UNITED STATES PATENT AND TRADEMARK OFFICE

APPLICATION NO.	FILING DATE	FIRST NAMED INVENTOR	ATTORNEY DOCKET NO.	CONFIRMATION NO.
09/750,474	12/28/2000	William J. Harrison	ACS-55966 (26991)	6584

Office Action Summary

DETAILED ACTION

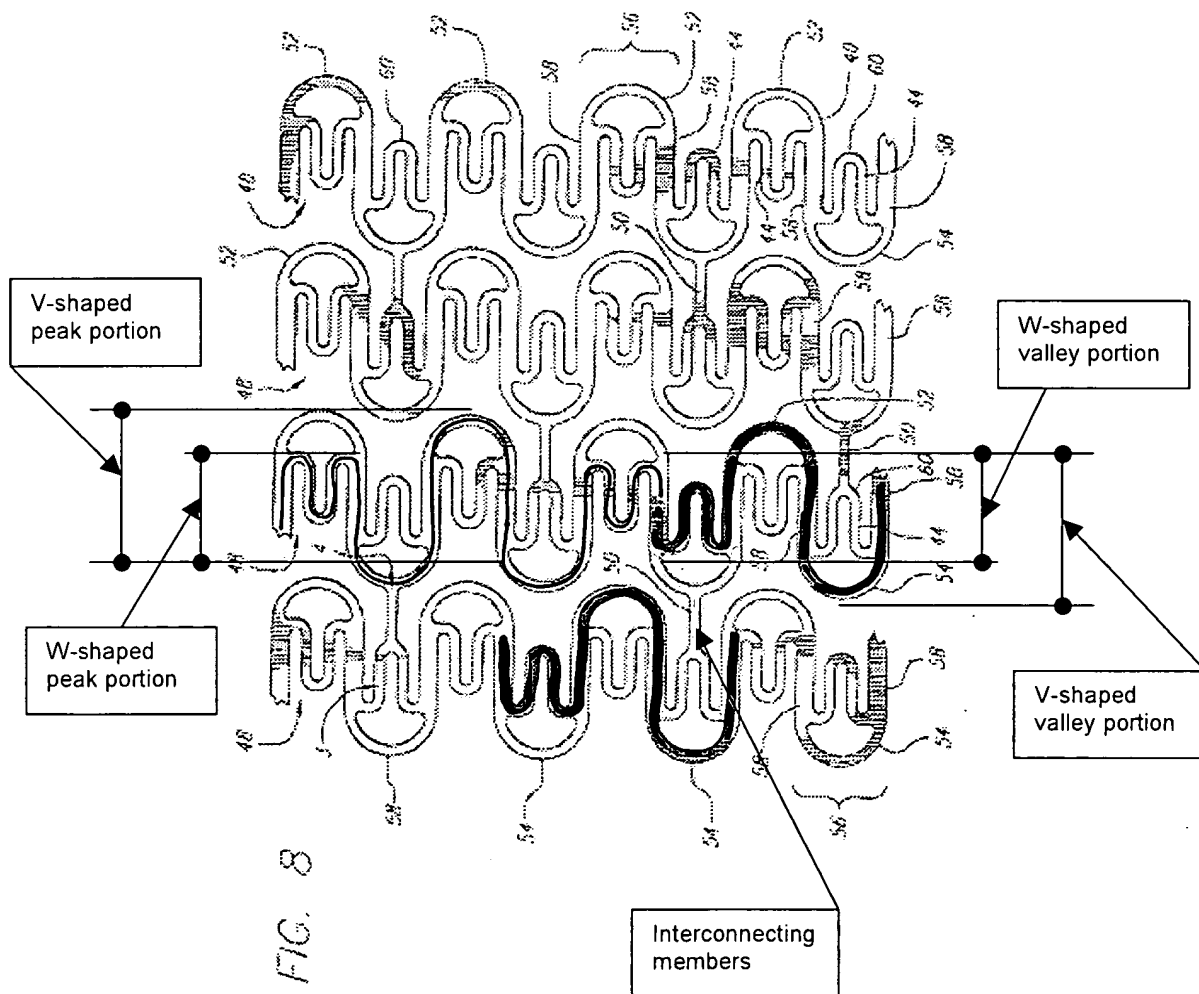
As to claims 1, 3-4, 6-7, and 21-22, ALLEN (see Fig. 8 reproduced and shown in page 3) discloses a balloon assisted expanding stent (see page 2, lines 1-6, section [0016]) or a self-expanding stent (see page 2, lines 7-10, section [0018]) comprising V-shaped and W-shaped peak portions (in red color), V-shaped and W-shaped valley portions (in green color), wherein W-shaped portions are smaller in length than the V-shaped portions as recited in the claims.

As to claims 8-10, ALLEN (see Fig. 8 reproduced and shown in page 3) discloses a stent comprising V-shaped and W-shaped peak portions (in red color), V-shaped and W-shaped valley portions (in green color), wherein W-shaped portions are smaller in length than the V-shaped portions as recited in the claims. Further as to claims 13-16 and 11, Fig. 8, page 3, shows valley portions (in green color) and a connecting member (in yellow color) as recited in the claims.

As to claims 17-19, ALLEN (Fig. 8 reproduced and shown in page 3) discloses each cylindrical element has at least 4 W-shaped valley portions adjacent to at least 4

V-shaped valley portion and W-shaped valley portions are smaller than V-shaped valley portions.

As to claim 23, see ALLEN's Fig. 8, page 3.

As to claim 20, ALLEN (Fig. 8) does not show 8 peak portions and 8 valley portions. However, it would have been obvious to one of ordinary skill in the art to provide 8 peak portions and 8 valley portions to ALLEN stent as claimed to make a stent having larger diameter to fit a larger blood vessel.

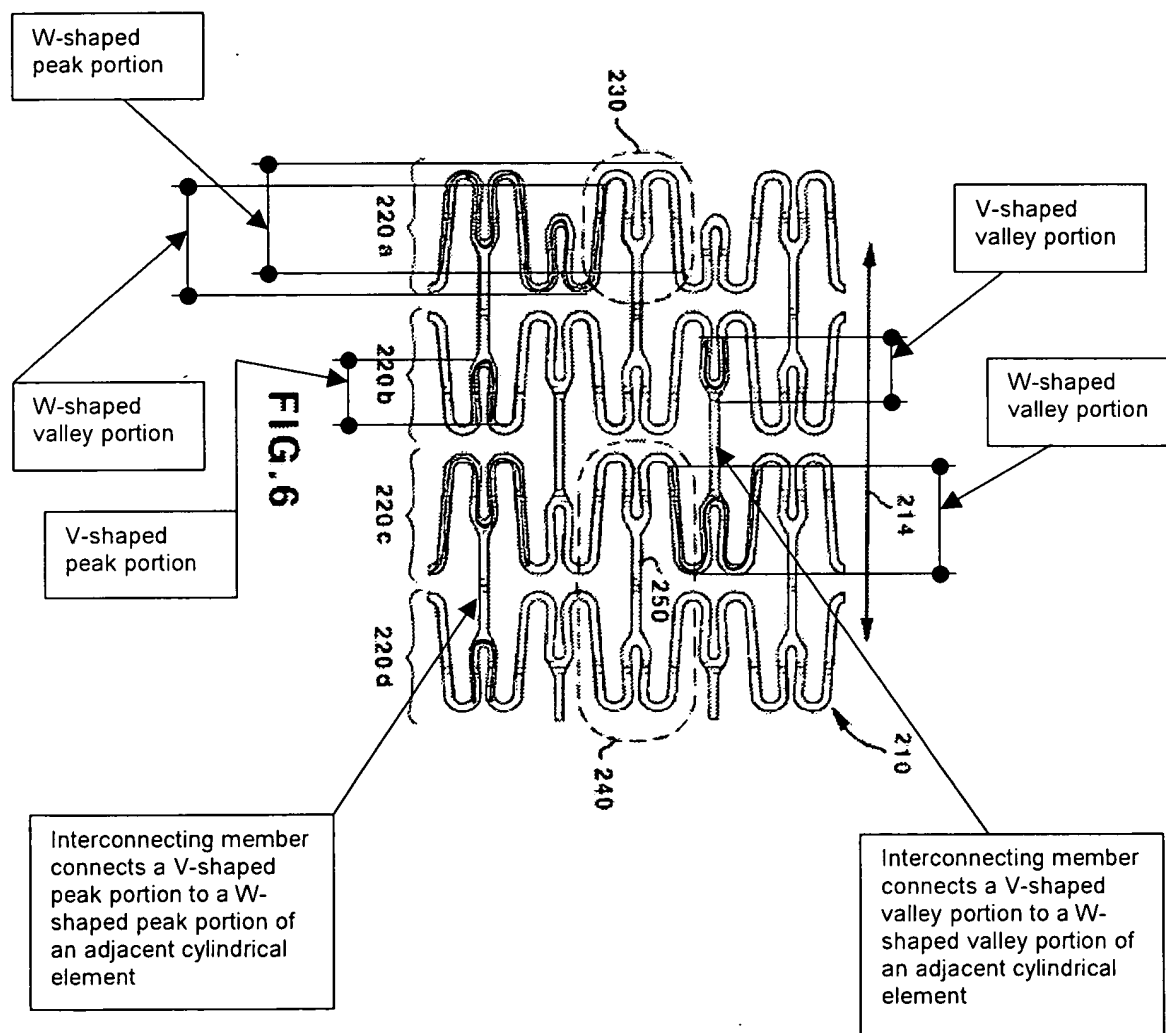
As to claims 24-29, see DANG's Fig. 6, this page.

As to claim 30, see DANG's Fig. 6, this page.

As to claim 31, see DANG's Fig. 6, this page.
